Wellington South Battery Energy Storage System (BESS) – Environmental Impact Statement

Thank you for your e-mail dated 16 November 2022 to the Biodiversity, Conservation and Science Directorate (BCS) of the Department of Planning and Environment (DPE) inviting comments on the Biodiversity Development Assessment Report (BDAR) for the Wellington South Battery Energy Storage System (BESS).

Wellington South Battery Energy Storage System (BESS) – Biodiversity Development Assessment Report

Figure 1: PCT 9999 and PCT 0 containing what appears to be vegetation

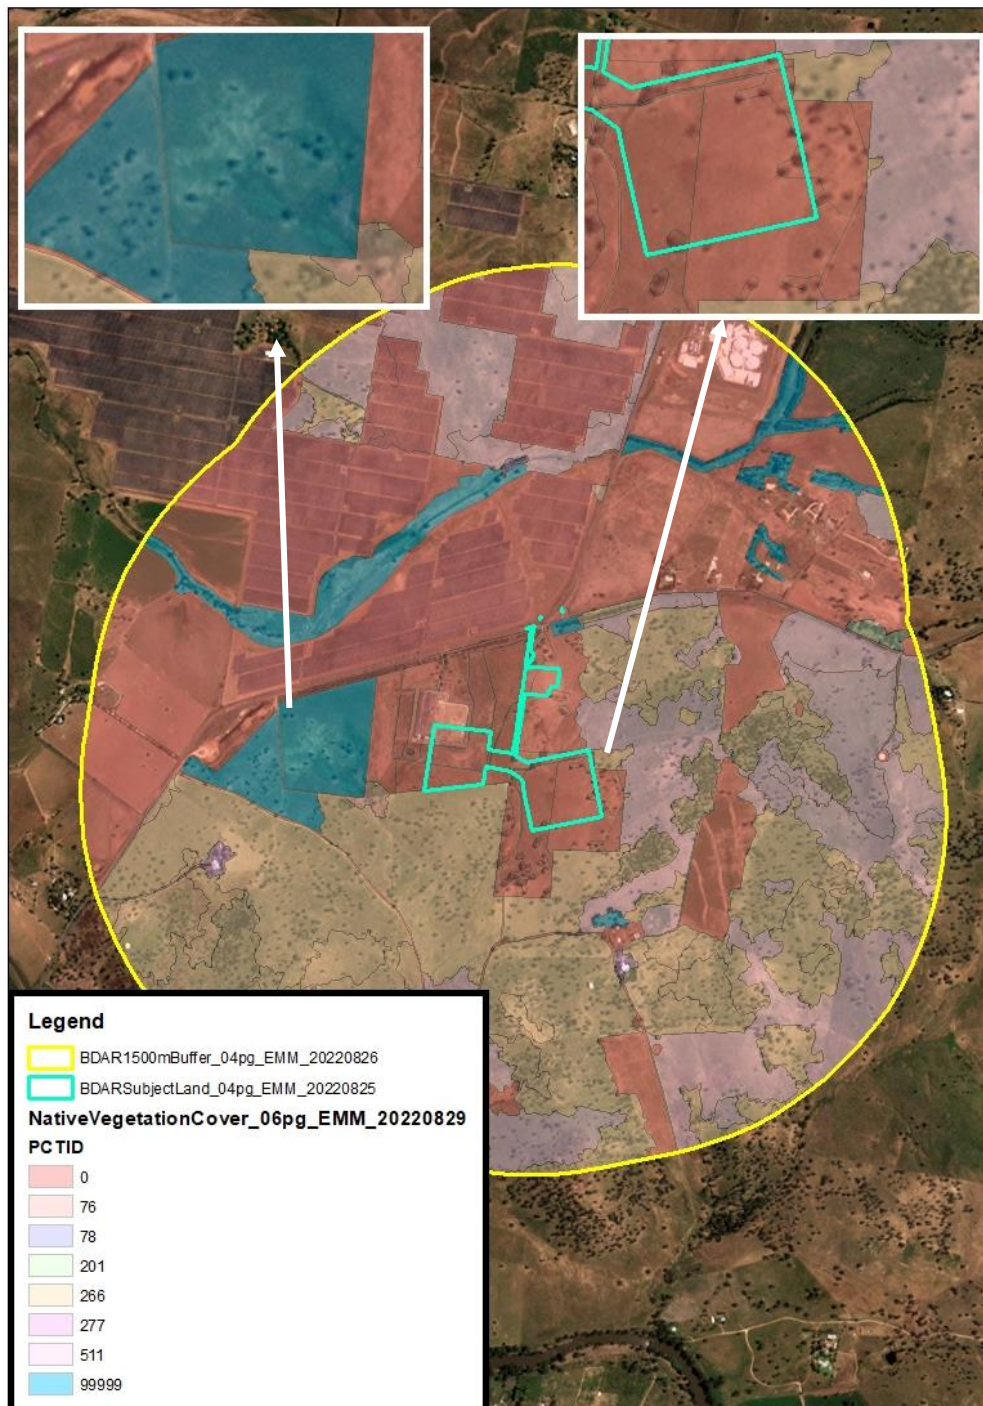
BSC notes that the proponent has mapped all areas within the 1500m buffer as native vegetation within the spatial data file *'NativeVegetationCover_06pg_EMM_20220829'*. However, it is unclear to BSC which vegetation zones or land categories are represented by *PCT 0* and *PCT 99999*. There are areas within these zones that appear to be vegetated on the aerial imagery, however they have not been mapped as a recognized PCT, so it is unclear whether they have been included in native vegetation cover calculations or accounted for in the impact assessment..

- 2.1 Revise the vegetation mapping to clearly delineate between native vegetation, non-native vegetation and Category 1 land and provide justification for each in the BDAR
3. 2.2 Revise the vegetation mapping to include all native vegetation

Figure 2: Subject land is mapped as PCT 0 in NVC spatial layer (left), and a combination of PCT 0 and PCT 266 in the PCT mapping layer (right).

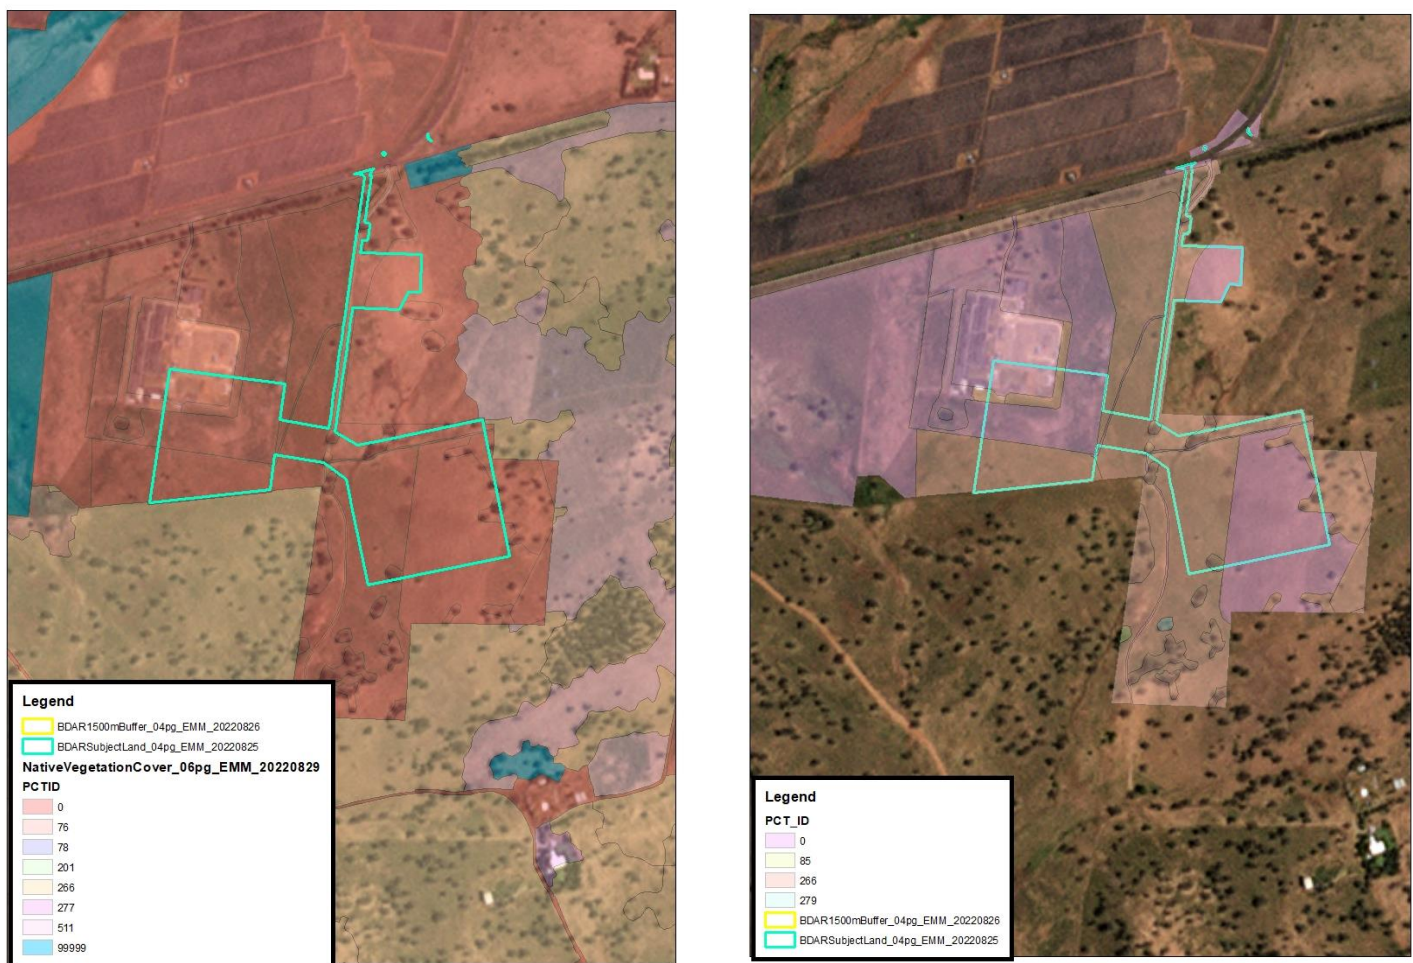
There are also discrepancies in PCT mapping between the 'NativeVegetationCover_06pg_EMM_20220829' (NVC layer) and the 'PCTMapping_07pg_EMM_20220829' (PCT layer). The NVC layer indicates that all vegetation within the subject land is PCT 0 (non-native), whereas the PCT mapping layer shows that the subject land is comprised of PCT 0 and PCT 266. Figure 4.1 of the BDAR displays this area as a combination of non-native and derived grasslands.

Figure 4: Inconsistencies between hollow-bearing tree spatial data and the species polygon for Superb Parrot in Figure 6.3 of the BDAR

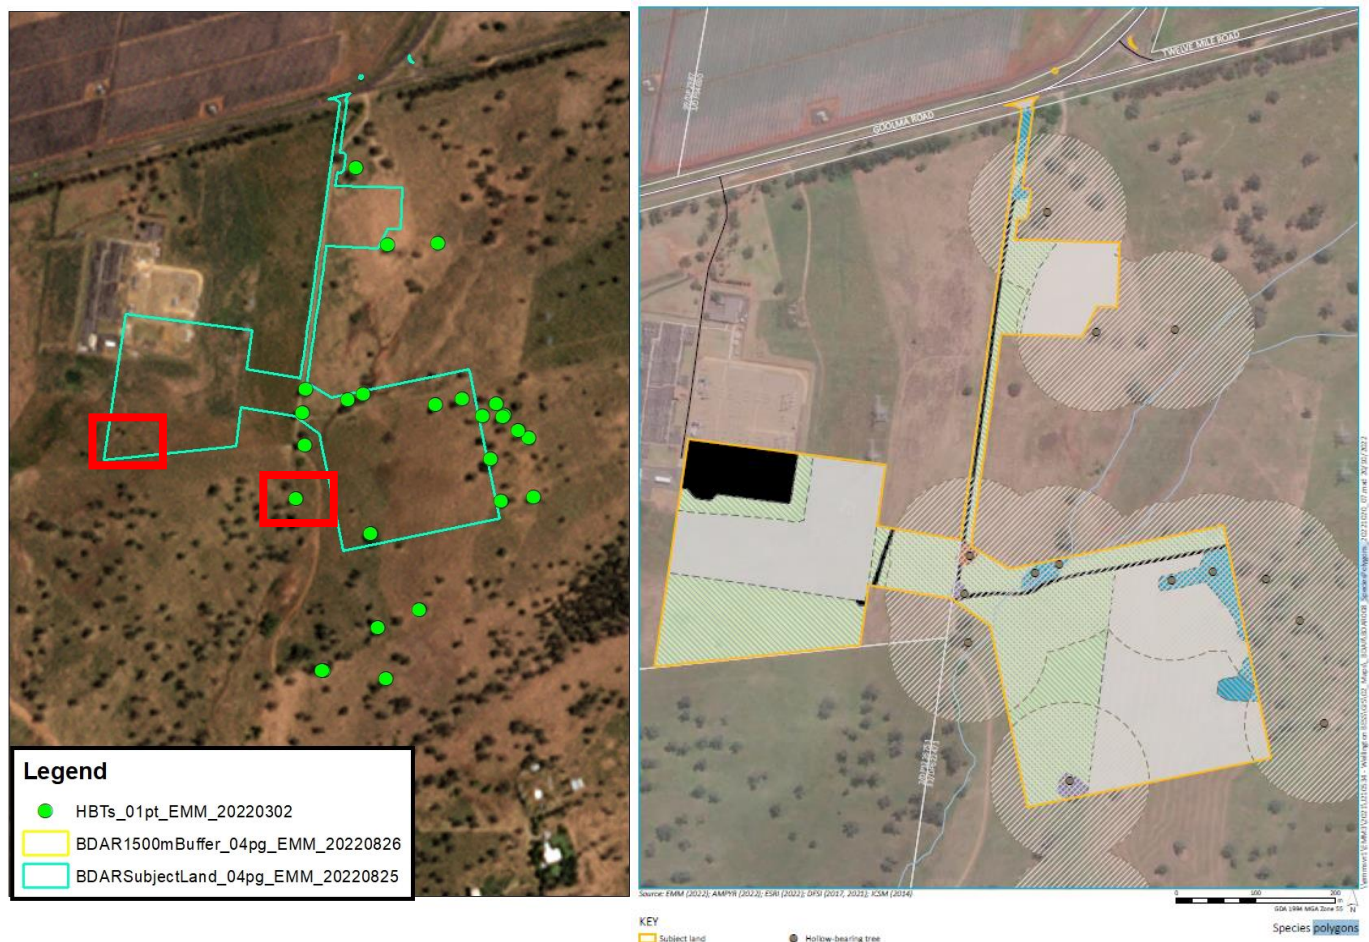
5. Table 5.11 of the BDAR only contains very high-level information regarding the method undertaken to prepare species polygons and no detail regarding the habitat which has been excluded from species polygons. The BDAR states that a 100m polygon should be constructed around all areas surrounding hollows that could be used for breeding, as per the TBDC. BSC has reviewed the spatial data provided and has observed that at least one suitable hollow bearing tree has not been included in the species polygon.

In addition, it appears that a number of additional hollow-bearing trees may be present in the south western extent of the project site in unsurveyed habitat.

- 5.1. Review and/or revise the Superb Parrot species polygons based on the presence of suitable or potential hollow bearing trees
